# SITE DEVELOPMENT PLAN DORSEY CENTER APARTMENTS, PARCEL 'T' 1ST ELECTION DISTRICT HOWARD COUNTY, MARYLAND

PLEASE NOTE THAT THIS REVISION SUPERSEDES AND REPLACES THE NOVEMBER 2020 BEI PLAN SHEET.

MARYLAND STANDARDS AND SPECIFICATIONS FOR SOIL EROSION AND SEDIMENT CONTROL  
U.S. DEPARTMENT OF AGRICULTURE NATURAL RESOURCES CONSERVATION SERVICE 2011

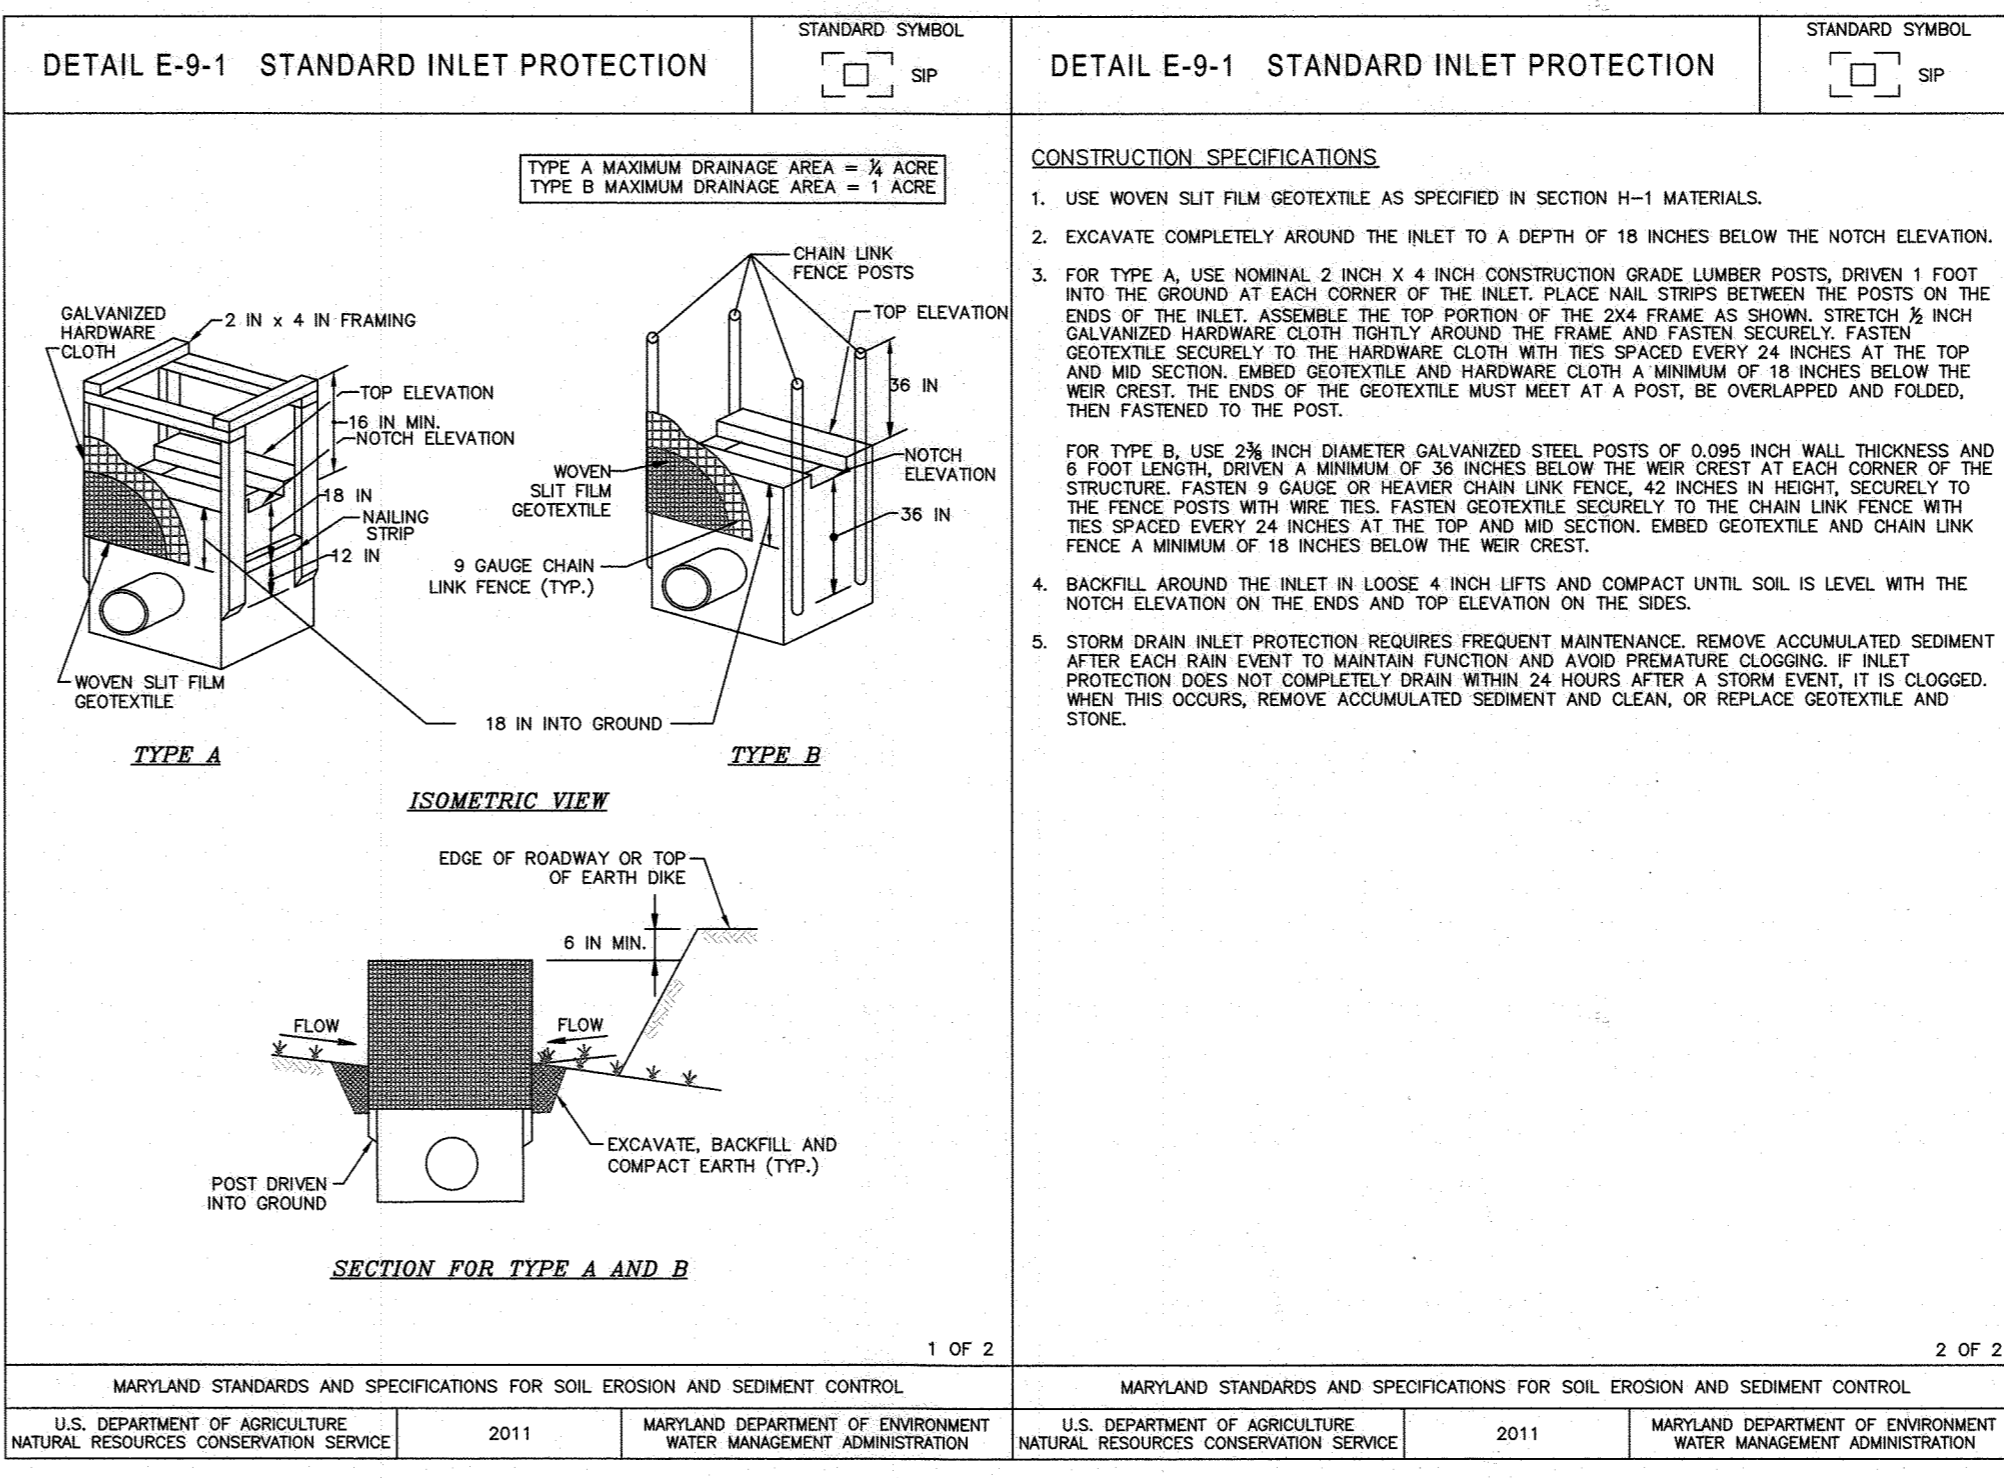
| NO. | DATE | REVISION   |
|-----|------|--|
| 1   | 4/23 | REVISED INLET PROTECTION LOCATION TO MATCH REVISED LANDSCAPE DRAINS, AND SHOW REVISED AND OFFSITE GRADING. |

| SCALE: AS SHOWN  | DRAWING 11 OF 49   |

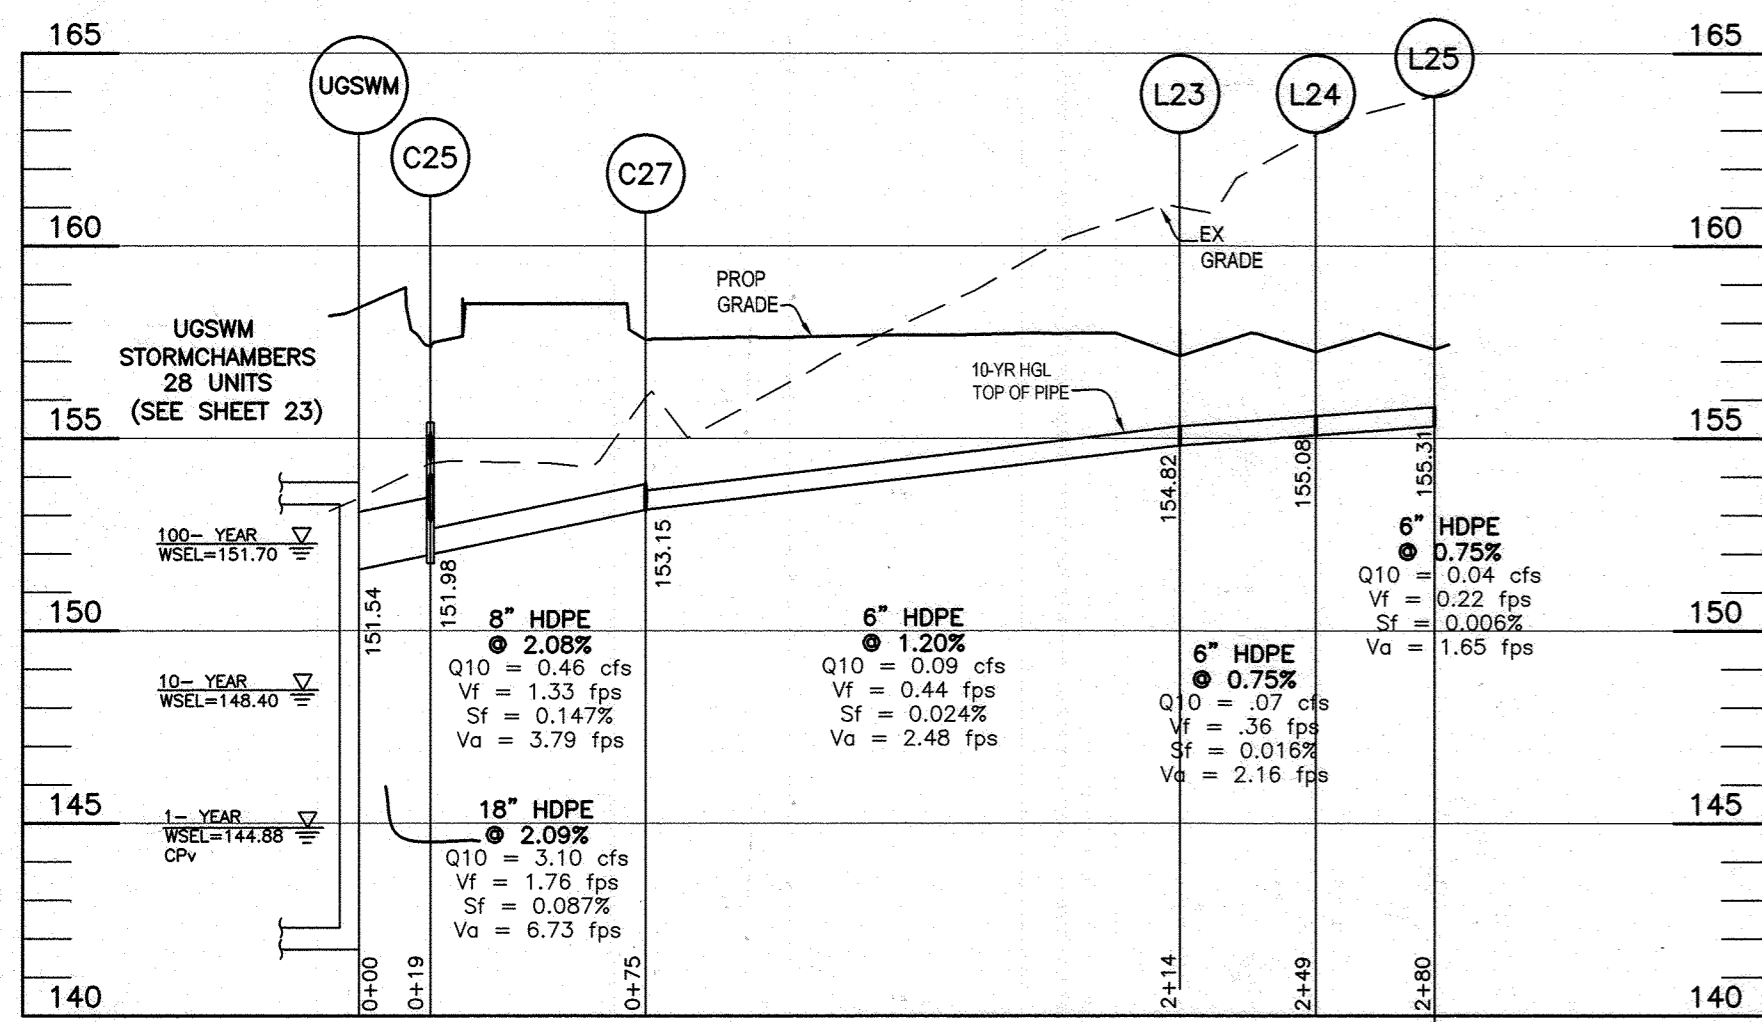
| NO. | DATE | REVISION   |
|-----|------|--|
| 1   | 4/23 | REVISED LANDSCAPE DRAINS AND FRONT AND REAR WALK/RAMP CONFIGURATION. |

|  | DRAWING 12 OF 49   |

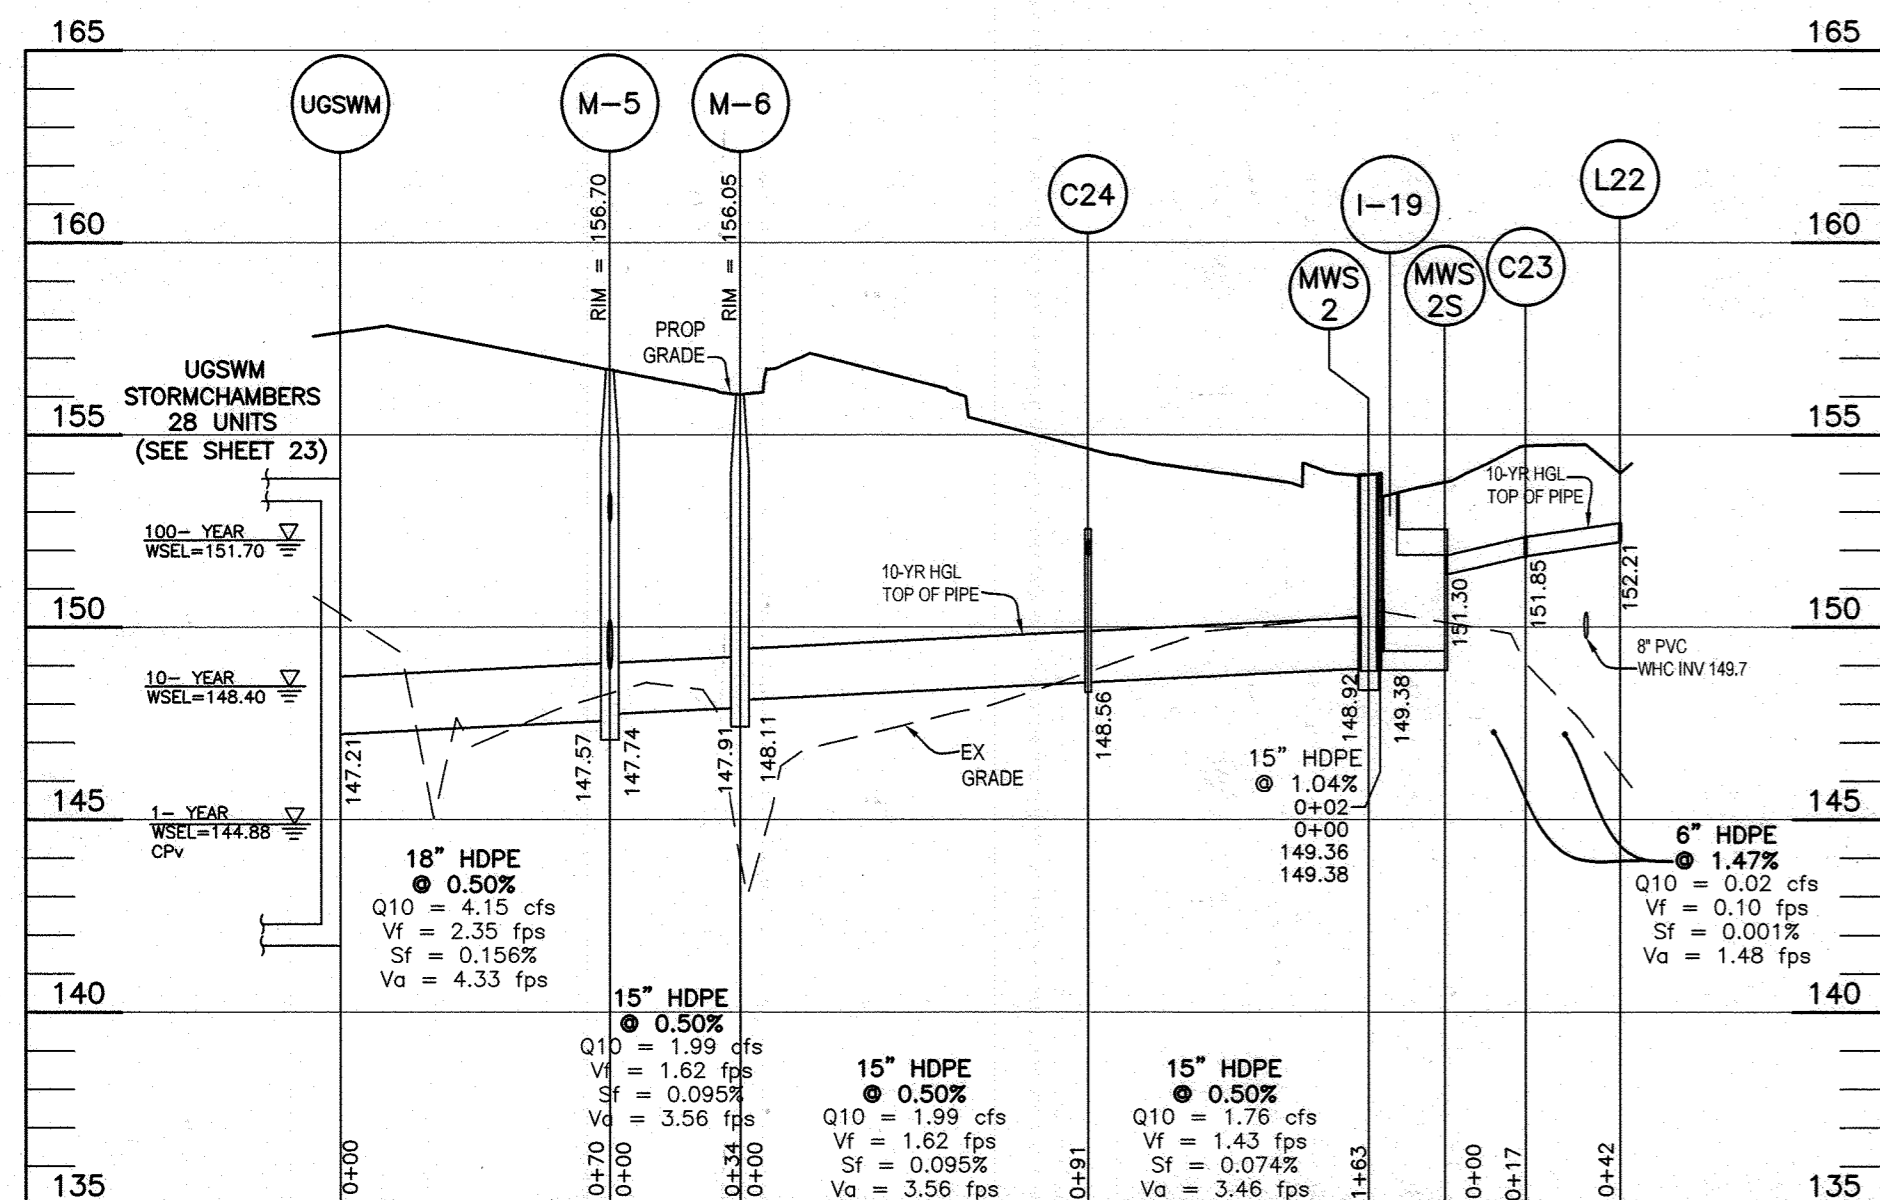
| NO. | DATE | REVISION                                     |
|-----|------|--|
| 1   | 4/23 | REVISED STORM DRAIN PROFILE FROM C27 TO L25. |
